Delegated Decisions by Cabinet Member for Transport

Thursday, 16 July 2026

ADDENDA

3. Petitions and Public Address (Pages 3 – 12)

Carterton

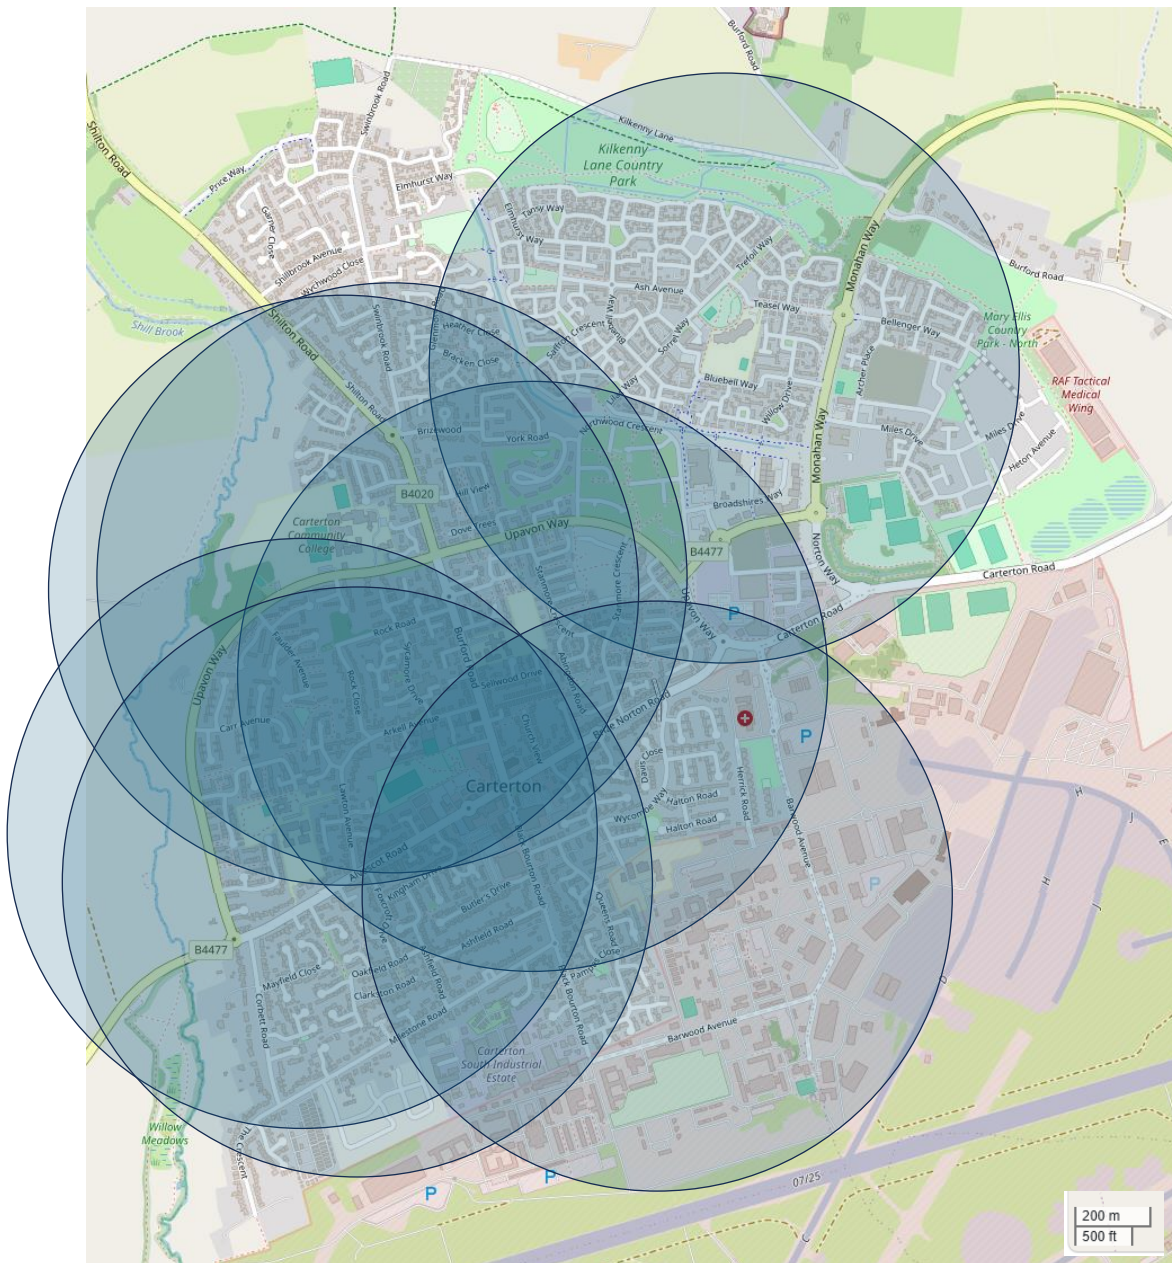
We agree with many that there should be more 20mph coverage near schools. Virtually all of Carterton is within 15 minutes' walk of a school, and so all roads should be 20mph.

We are particularly concerned at the proposals to remove from the proposal the section of Upavon Road outside Little Giants Nursery and Carterton Community College, and the section of Burford Road outside Carterton Primary School. These two sections we strongly believe should be reinstated in the scheme. We note the near universal support for 20mph near schools and that the relevant bus company did not object to the scheme.
